MEMORANDUM

SUBJECT: BZA Case 18544, 1550 Pennsylvania Avenue SE, request for variance and special exception relief to allow the construction of a five-story apartment building

CASE NO. 18544
EXHIBIT NO. 25

Subject Property

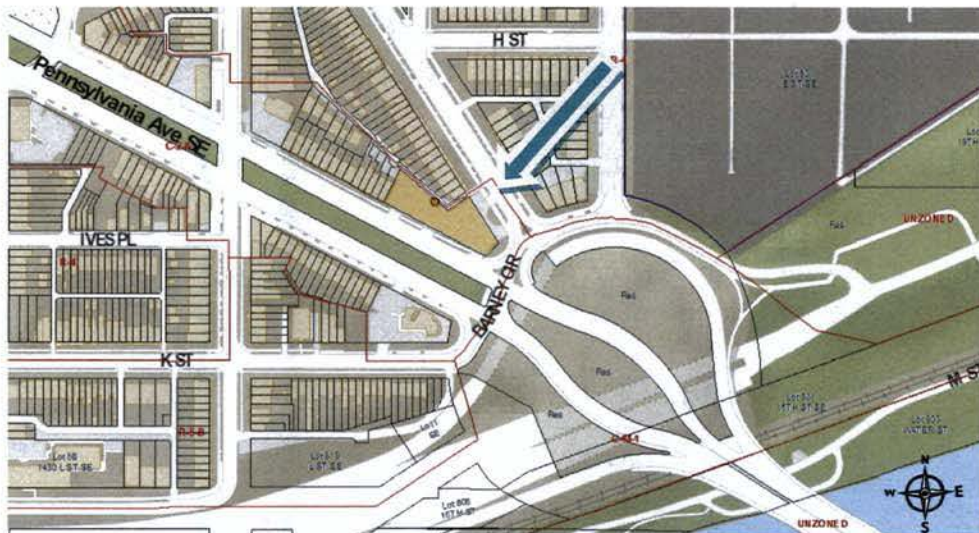
The Applicant proposes to construct a five-story residential building with 82 units. The project would also include 30 parking spaces (22 underground spaces and 8 other spaces adjacent to the public alley). To accommodate the proposed development, the Applicant has requested a variance from the required 41 parking spaces, size of parking spaces, and loading, as well as a special exception from roof structure requirements. The Applicant's revised proposal, dated April 14, 2013, would widen the alley into the Applicant's property, reduce the proposed number of parking spaces to 30, reduce the maximum number of residential units to 82, (thereby reducing the required number of required parking spaces to 41), and increase the number of compact spaces from 2 to 11.
